## ASSESSMENT REPORT

### Section 75W Modification (MP 08\_0157 MOD 2) Minto Malting and Grain Project Additional Storage Silos

Figure 4: Existing site layout and proposed modification (see highlighted in yellow)

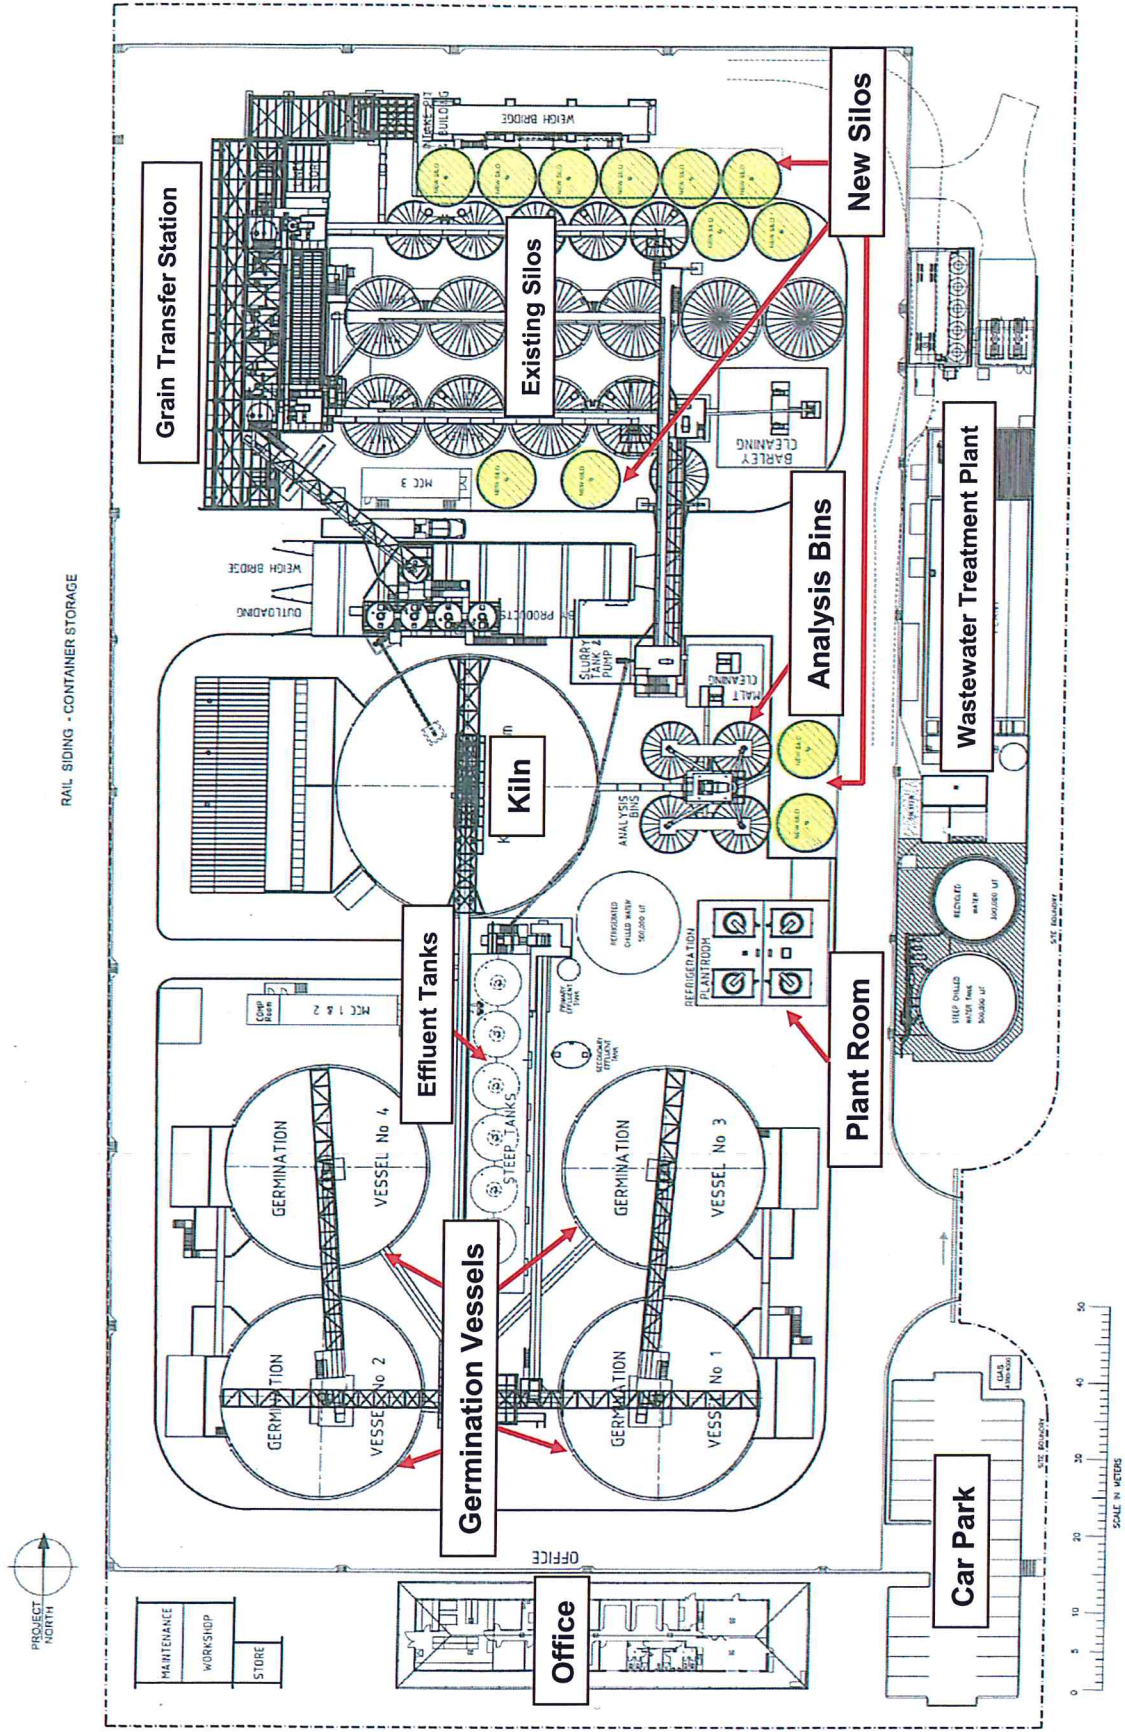
The new silos would be constructed using galvanised steel and would match the existing smaller silos on site (see Figure 3). Each silo would be 22 metres (m) high, have a diameter of 7.31m and a storage capacity of around 721m<sup>3</sup> per silo (i.e. around 254.6 tonnes).

The new silos would be designed to be filled and emptied via overhead conveyors which are sealed and would be extended from the existing silos on site (see Figure 3).

The proposed modification to the existing site layout is illustrated in Figure 4 below.
